REVISION III TO VOLUME IV OF IV REPLACEMENT AMENDMENT TO FINAL CLOSURE PLAN

LOPEZ CANYON SANITARY LANDFILL LAKE VIEW TERRACE

SUMMARY OF REVISIONS FINAL CLOSURE AND POST-CLOSURE MAINTENANCE PLANS LOPEZ CANYON SANITARY LANDFILL

SUMMARY TABLE OF REVISIONS TO VOLUME IV OF IV REPLACEMENT AMENDMENT TO FINAL CLOSURE PLAN Revision III – November 2002

FIGURE NO.	2-2(c)
PROJECT NO.	CE4100-02
DOCUMENT NO.	LP702-32
DATE:	NOVEMBER 2002

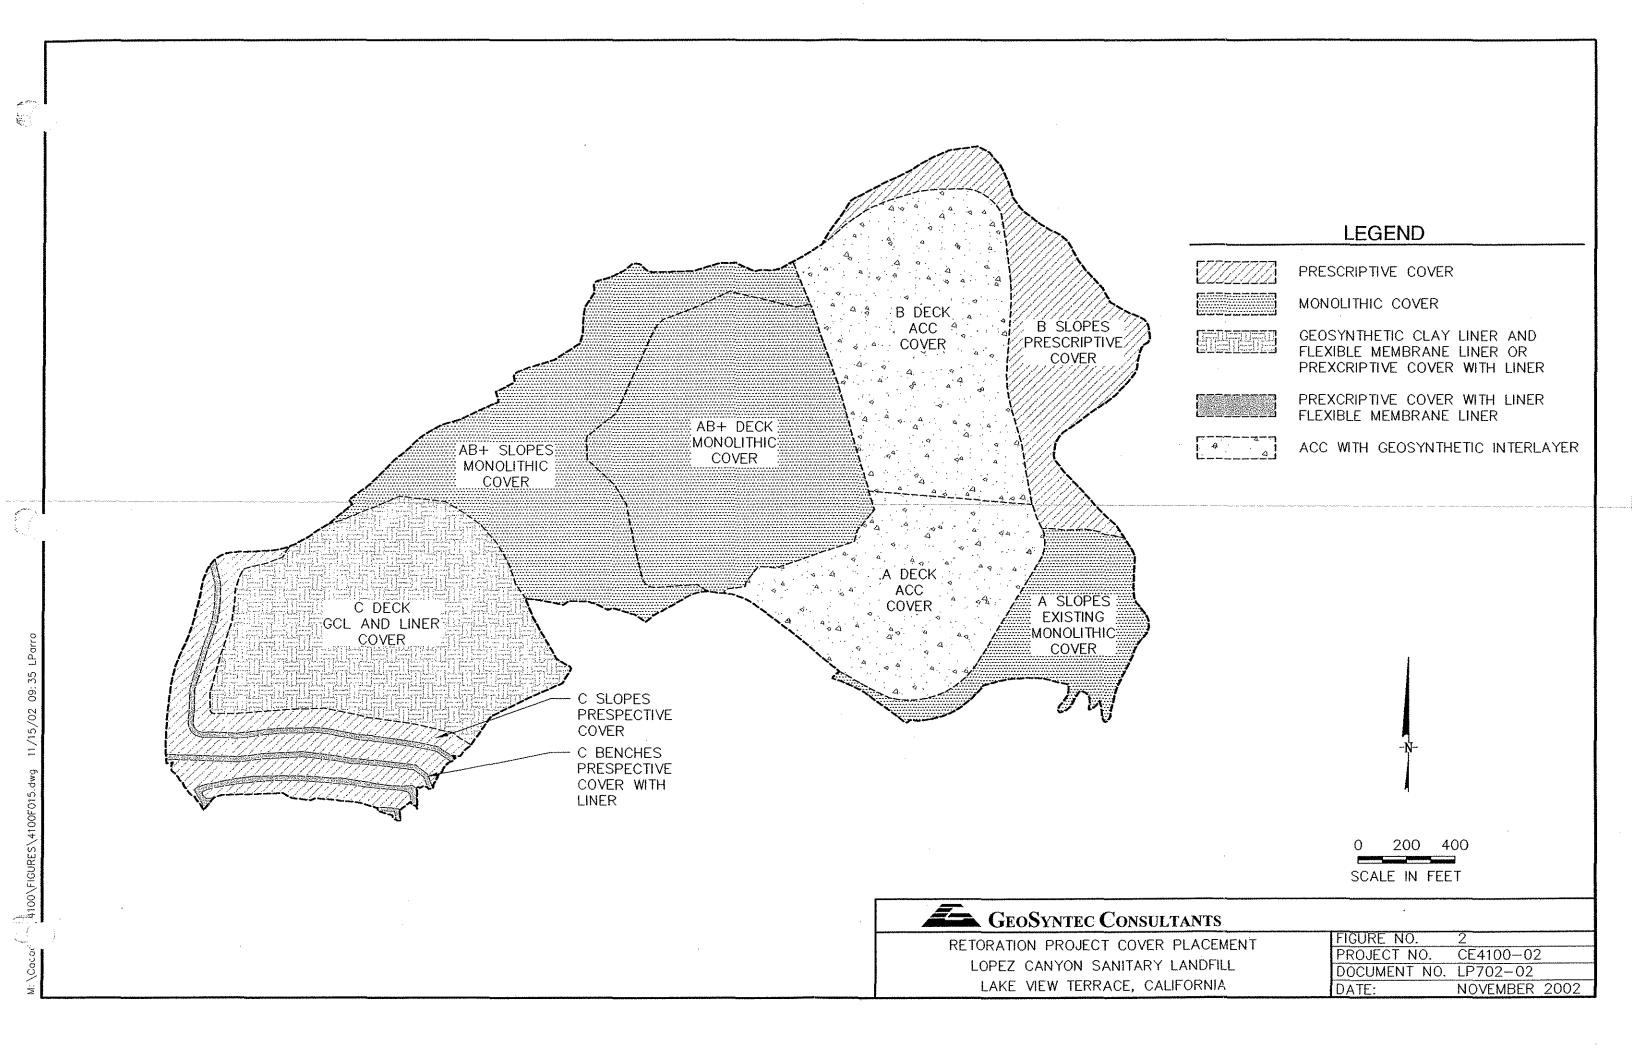
The revised final cover for the decks of Disposal Areas A and B consists of Asphaltic Cement Concrete with an internal tack-coat impregnated geosynthetic reinforcement inter-layer. This design has been demonstrated to meet the performance requirements for an engineered alternative final cover (i.e., it performs as well or better than the Title 27 prescriptive cover with respect to groundwater protection, waste isolation, and gas control). Documentation of the performance of the proposed Asphaltic Cement Concrete cover is provided in Appendix L.

The final cover on the deck of Disposal Areas A and B has been modified from that presented in the PCP. Two different final cover configurations are now proposed for these areas. In the areas to be occupied by the composting facility, an Asphaltic Cement Concrete final cover will be employed. Outside of the composting facility, the final cover will consist of a three-foot evapotranspirative monolithic cover of silty sand or clayey sand with a field saturated hydraulic conductivity no greater than 3×10^{-5} cm/, overlying a minimum of a two-foot existing foundation layer.

The Asphaltic Cement Concrete final cover is shown in Figure 2-2(c).

FIGURE NO.: 5-2

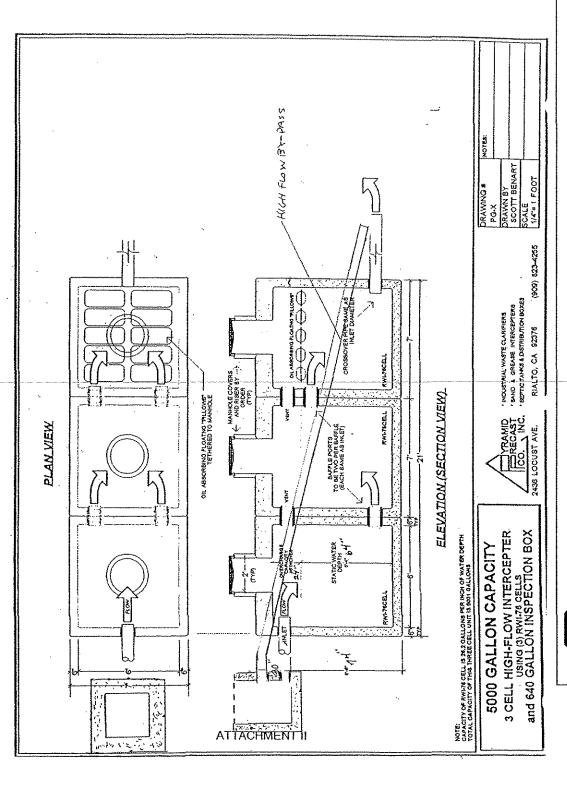
The deck of Disposal Area B has been modified to accommodate construction of the composting facility. The grading has been modified to direct the surface water run-off to an inlet structure equipped with a clarifier (Figure 5-2). Surface water run-off collected at the inlet structure will flow into a pipe connected to surface drainage line E and thence into the upper sedimentation basin located on Bench B4.
